**Subject: MHI's Responses to NRC's Requests for Additional Information on Advanced Accumulator for US-APWR Topical Report MUAP-07001-P, Revision 2**

**MHI's Responses to NRC's Requests  
for Additional Information**

**Advanced Accumulator for US-APWAR Topical Report  
MUAP-07001-P, Revision 2**

Fig. 33-1 Example of Distension of a Nitrogen Bubble due to Gas Expansion

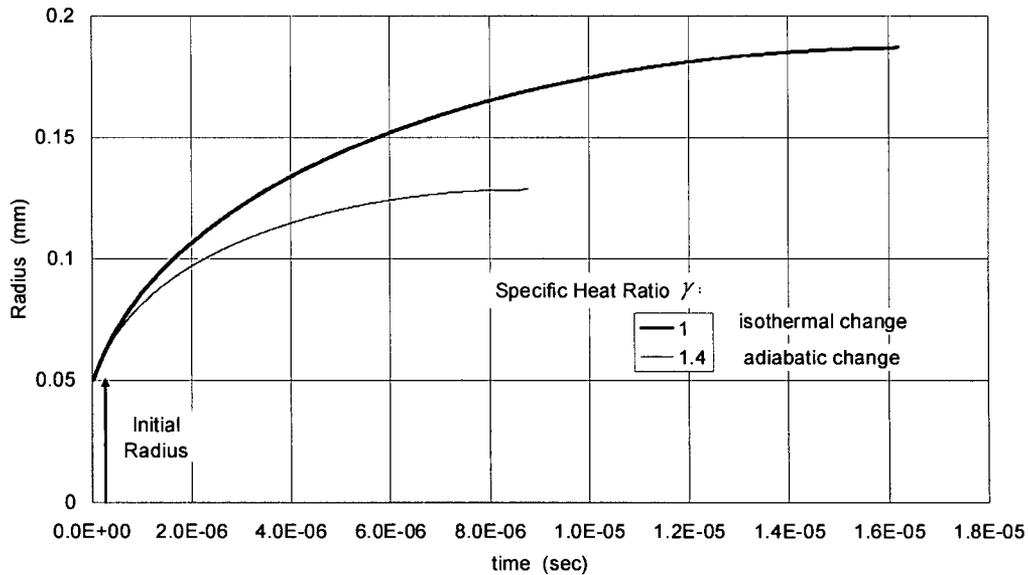
It will take time for accumulator to become saturated with nitrogen. The upper layer will saturate but thereafter, the dissolved gas will diffuse to the rest of the accumulator liquid. If there are any convection currents in the liquid, the mixing will be even faster. The response to RAI 5b dated September 2008, regarding the dissolved ratio of nitrogen in terms of diffusion period of 2 years through 10 years, does provide the actual concentration of the dissolved gas, and the dissolution of the gas as the fluid particles move to the lower pressure. The amount of gas that will evolve depends on the nucleation sites and interfacial area.

Why are the effects of nucleation sites, interfacial area density and convection not addressed, in addition to the diffusion process?

The pressure drop in the actual accumulator tank is slow. However, let's consider a nitrogen bubble that experiences abrupt depression from the storage pressure of 5.33MPa to an atmospheric pressure of 0.101MPa at time  $t=0$  sec as a stepwise to be able to examine the growth of the bubble as the most conservative. The bubble at first rapidly expands due to gas expansion, then nitrogen slowly permeates in water due to diffusion of saturated nitrogen. Bubble dynamics due to gas expansion in inviscid fluid is given by the following equation (L.D. Landau and E.M. Lifshitz: Fluid Mechanics, Pergamon Press, 1975):

The distension of a spherical bubble with an initial radius  $2 \times 10^{-3}$  in (0.05mm) due to gas expansion is shown in Figure 33-1. Surface tension on the bubble was taken into account in

the calculation. Bubble distension due to gas expansion is very rapid. For adiabatic change, or specific heat ratio  $\gamma=1.4$ , the bubble is distended in  $9 \times 10^{-6}$  sec, and for isothermal change, or  $\gamma=1.0$ , the bubble is distended in  $1.6 \times 10^{-5}$  sec. An actual bubble will be abruptly distended in time between them.

Fig. 36-1 1/2 scale Model of Flow Damper with full-height Standpipe

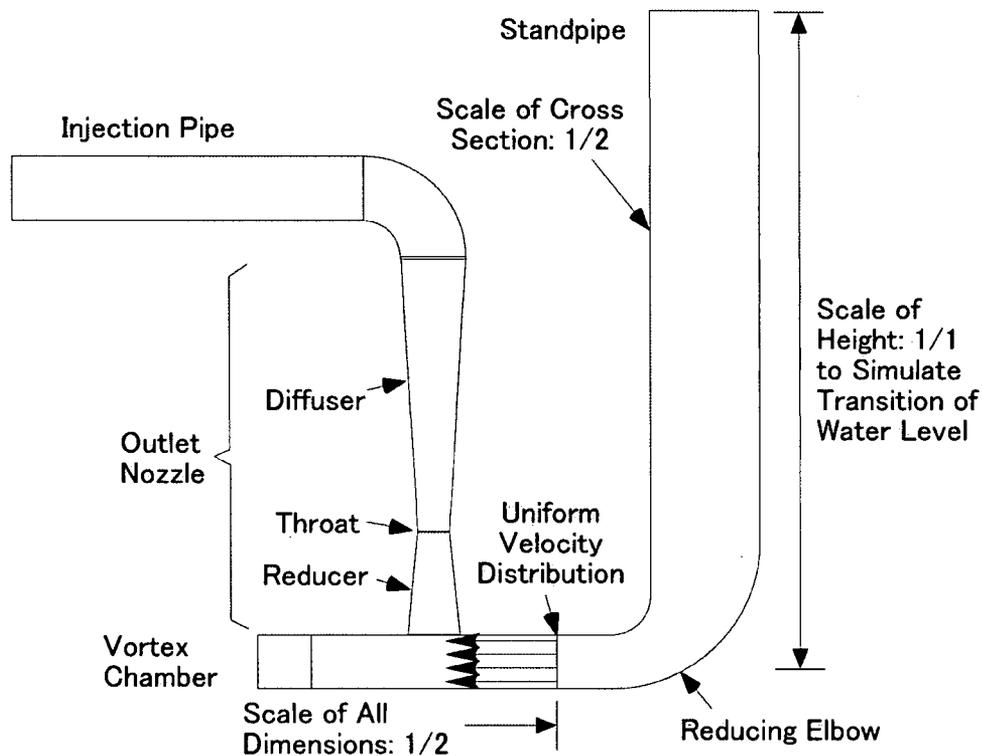
The accumulator characteristic correlations developed with the 1/2-scale accumulator test data indicate that the cavitation factor and flow rate coefficient are the only groups that represent important phenomena for high and low flow conditions.

(a) Are the cavitation factor and flow rate coefficient the only dimensionless groups that represent the important phenomena?

(b) In MHI's response to RAI 9-A (Sept, 2008), why is there no gravity term in the momentum equation? What are the boundary conditions (configuration)? What is the length scale (D) and the basis for being appropriate for all directions? Eq. 9-2 describes the local momentum balance. The statement below that Eq. states that the pressure loss is only function of Reynolds number. However, there is pressure loss beside the friction (viscous) loss that depends on the geometry. How is the pressure loss based on geometry preserved in different size facilities?

The states of flow in the full-height 1/2-scale model of the flow damper and the standpipe are shown in Fig. 36-1. The scale of all dimensions is 1/2 except the height of the standpipe. For large flow injection, the ratio of cross sectional areas of the standpipe and the large flow pipe is [ ] so that there is no flow separation in the elbow between them to make a uniform velocity distribution in the large flow pipe. In other words, the length of the standpipe does not affect the flow in the flow damper. In addition to that, the inlet of the standpipe below the anti-vortex cap is designed to have configuration without flow separation so that flow in the standpipe is uniform. The ratio of cross sectional areas of the accumulator tank and the standpipe is [ ], so the flow toward the inlet of the standpipe is rapidly accelerated for which the accumulator tank serves as a reservoir where water is almost at rest. Consequently, flow at the inlet of the standpipe is not affected by the flow conditions in the accumulator tank but only by the gas pressure. Friction losses in the standpipe for both the actual accumulator and the full-height 1/2 scale model are less than [ ] of the flow damper and negligible. Friction loss in the flow damper was evaluated with the data of 1/5 and 1/2 scale models, and the scale effect to friction loss was confirmed to be negligible for the operating conditions of the advanced accumulator. It is because the length of the flow path in the flow damper is less than that of the standpipe in addition to high Reynolds number.

For flow switching, a water column in the standpipe is in one dimensional motion as in water hammer analysis. Since it has actual velocity, actual amount of undershoot of water level happens in the full-height 1/2-scale standpipe so that simulation of water level transition in the standpipe can be realized. This is the reason the full height standpipe was chosen for the 1/2 scale model.

(a) Generally speaking, the dimensionless groups that represent the important phenomena are the cavitation factor, flow rate coefficient, Reynolds number and Froude number. Their roles are different from each other. Reynolds number represents effect of viscosity on flow resistance. Effect of viscosity is included in the flow rate coefficient which is less dependent on Reynolds number in the plant operating conditions. Since water is isothermal, gravity affects

only the boundary conditions at the free surface of water in the accumulator tank and the standpipe, and does not appear in the momentum equation. The cavitation factor directly affects the flow rate coefficient only when cavitation occurs.

(b) As mentioned in Response to RAI 9. UAP-HF-08174-P(R0), the boundary conditions are configurations of the model, inlet condition, namely, gas pressure in the accumulator tank, and outlet condition, namely, outlet pressure of the flow damper for the flow rate coefficient. The characteristic length (D) can be chosen as an arbitrary dimension except the heights of the standpipe and the accumulator tank. Then, the scale is 1/2 for all directions as shown in Fig. 36-1. The flow rate coefficient represents effects of the geometry and viscosity. The former is independent of Reynolds number, and constant for the flow damper with a given configuration for different size facilities. The latter is represented by Reynolds number which has less effect on the flow rate coefficient.

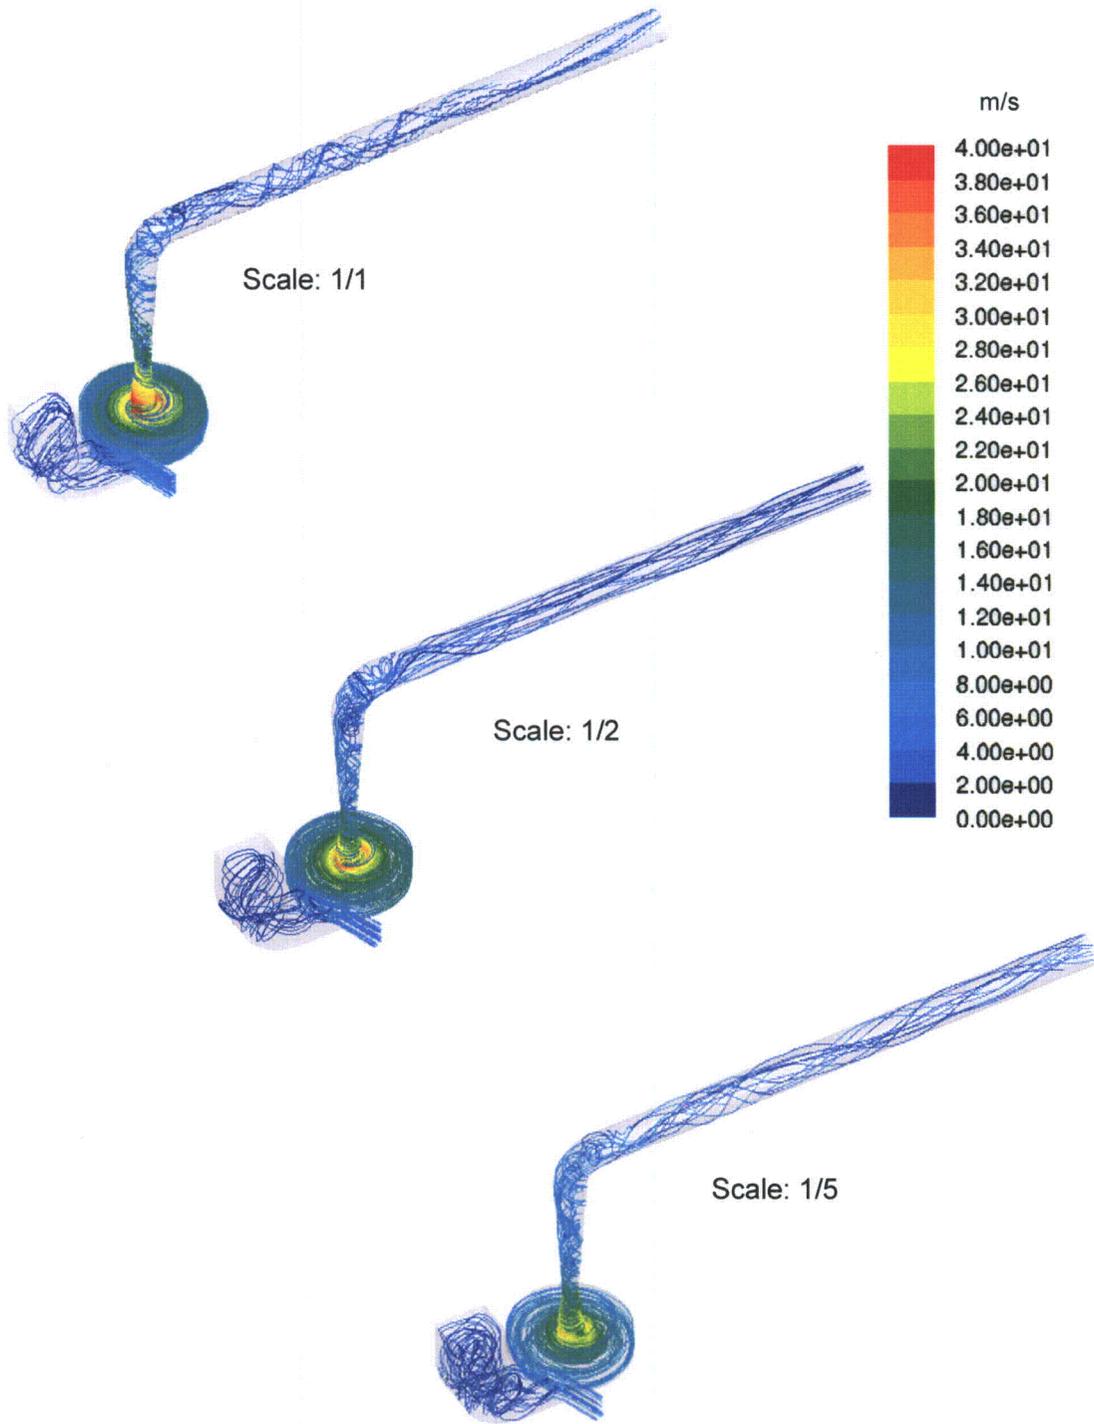
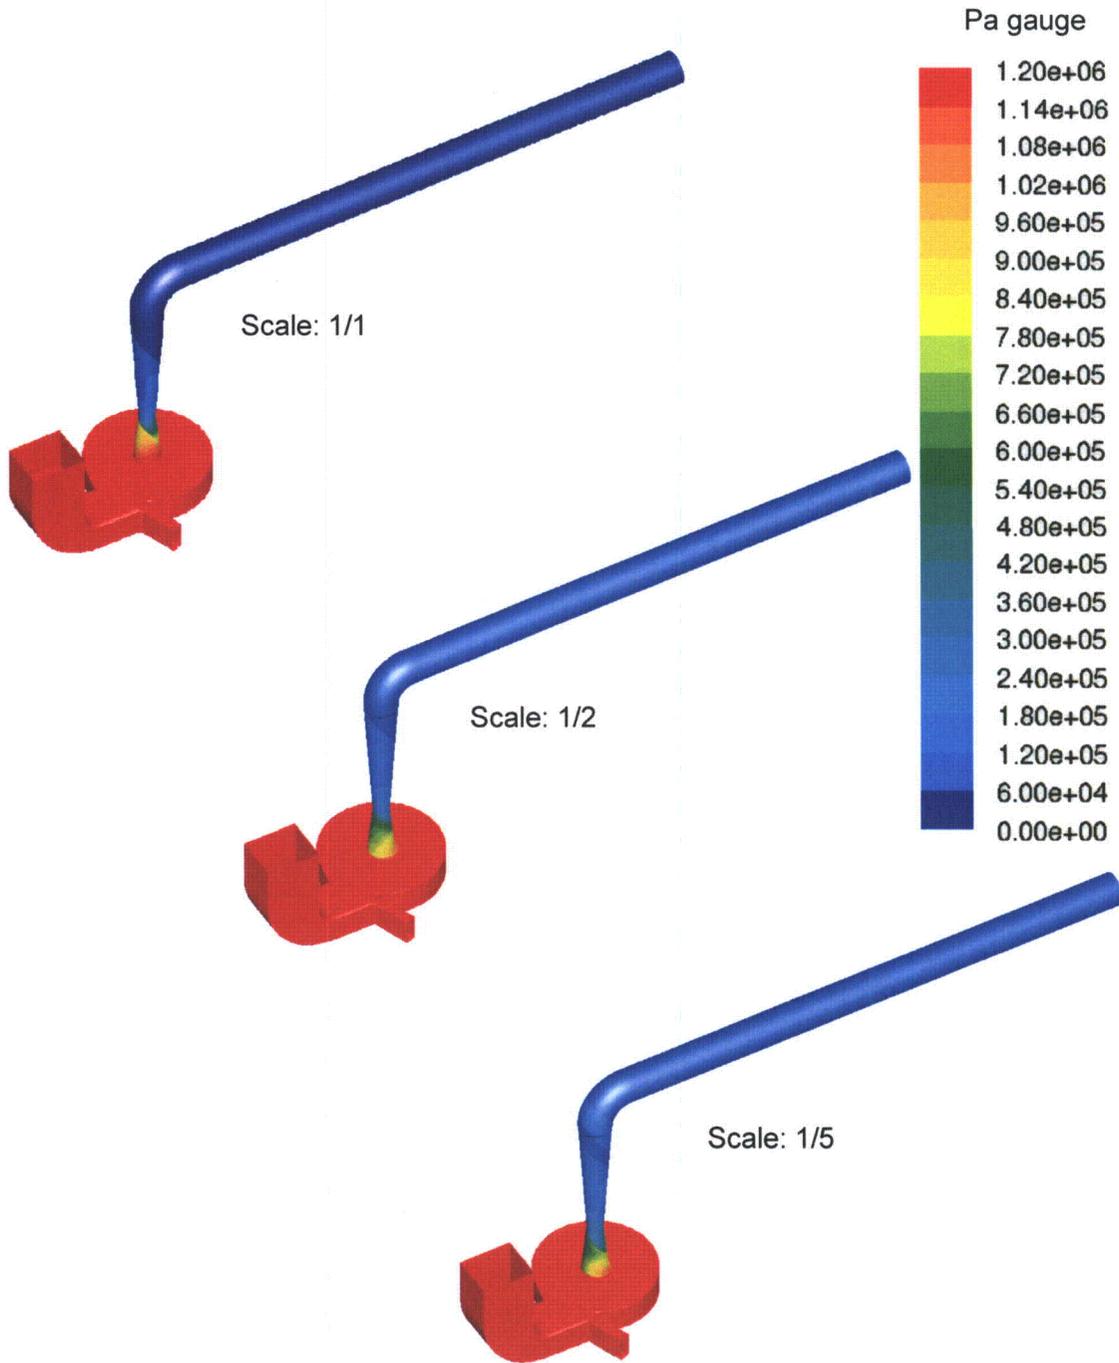
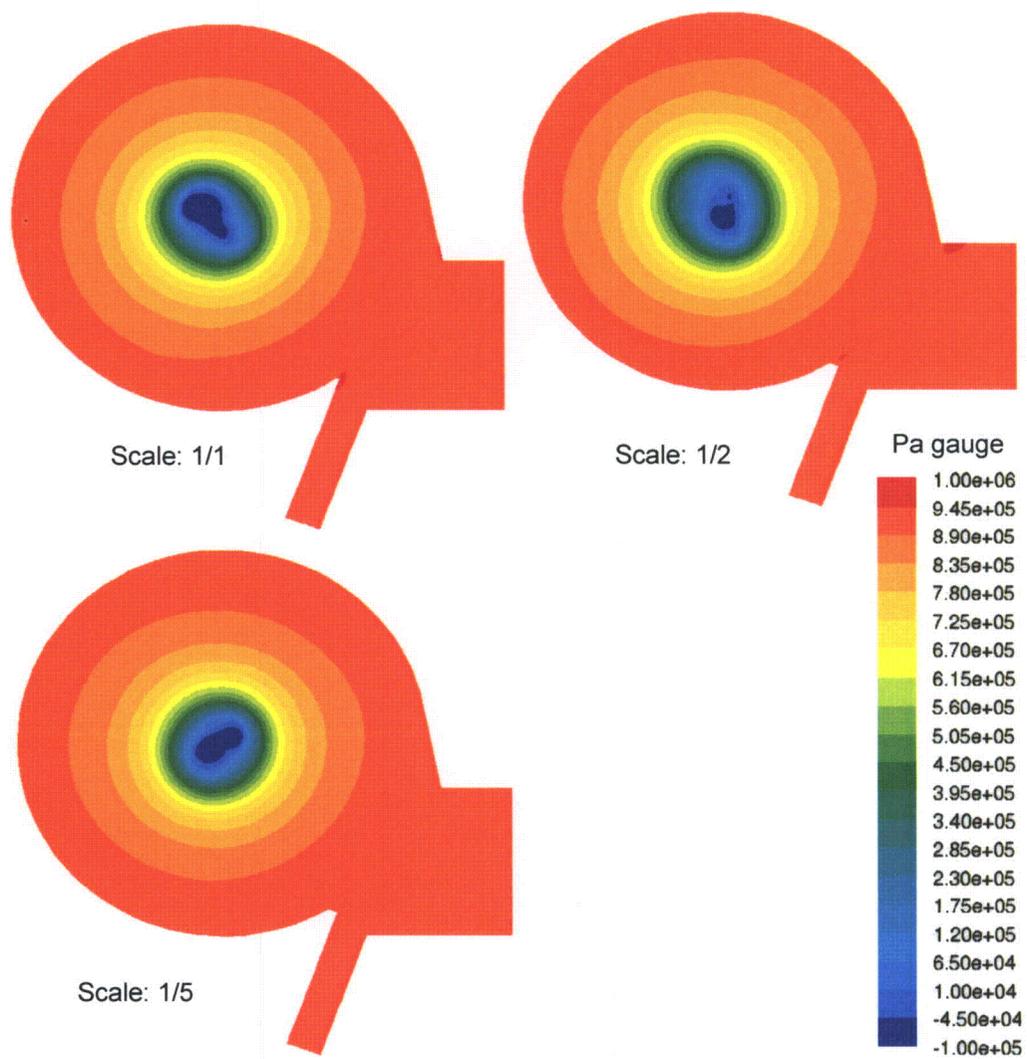
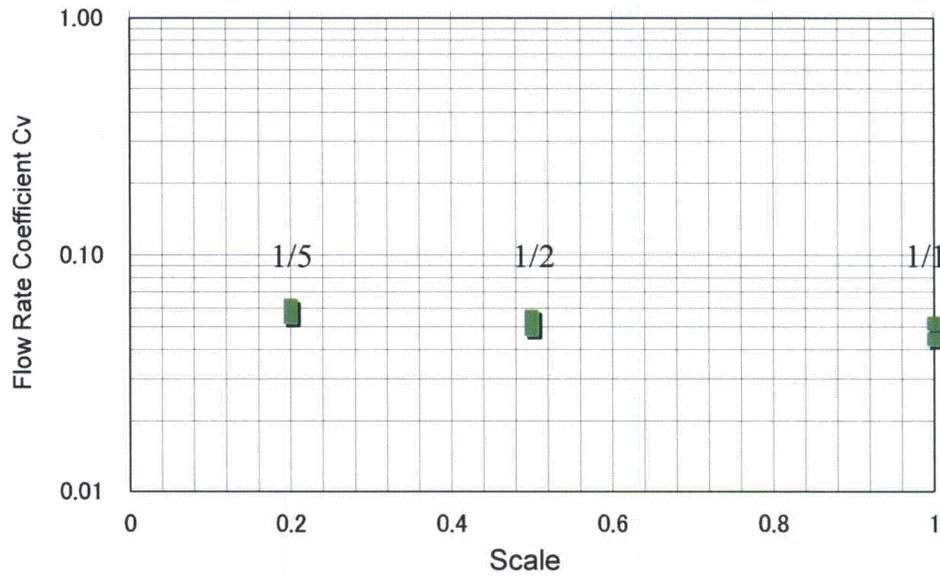
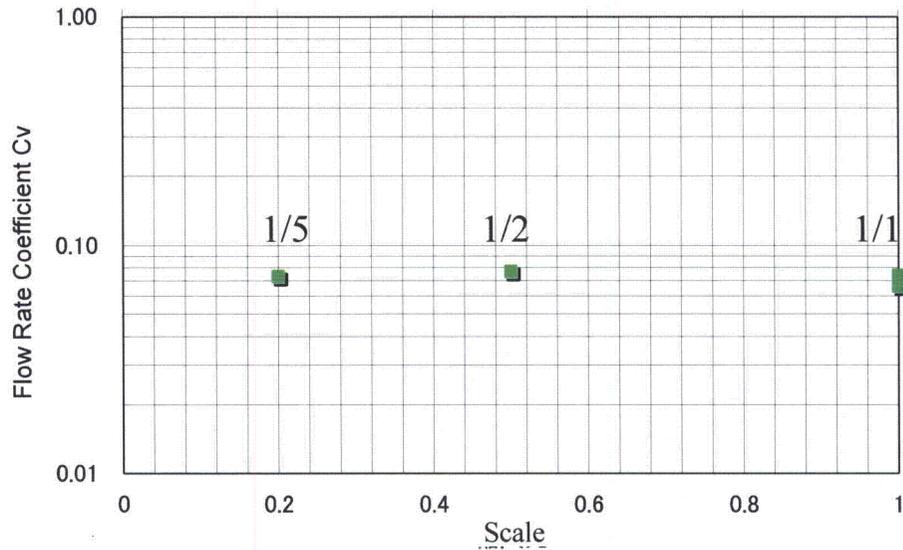
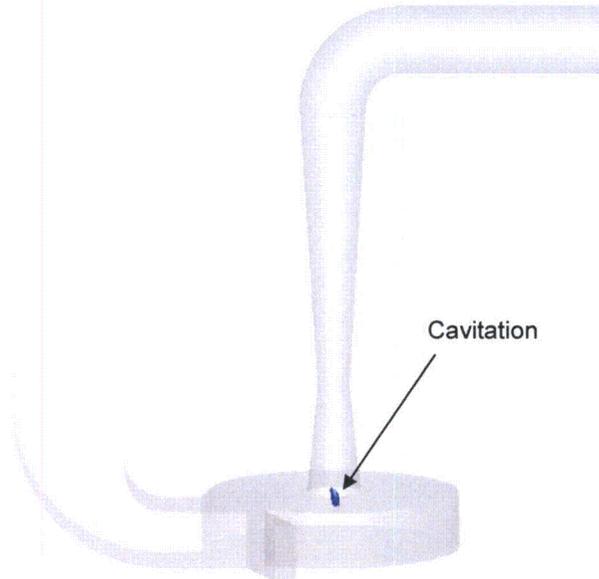
Provide any final report about the CFD calculations, including the case and data files used to make the conclusions about the flow performance map (i.e. flow rate vs. time) as well as cavitation throughout the time of performance of the accumulator during both the large flow rate and small flow rate conditions.

Figure 2 shows the flow patterns were similar to each other for 1/5- and 1/2-scale models, and the prototype.

The energy loss from the small and large flow pipes to the throat is about 90% of the total loss for all cases.

The static pressure distributions in the vortex chambers are similar to each other for all cases.

Flow rate coefficient is independent of model scale both for cavitation factor  $\sigma_v = 0.3$  and 9.4.

Cavitation may occur in the vortex chamber. Flow path surrounding the cavitation has larger area than that of the throat so that cavitation does not choke the flow rate.
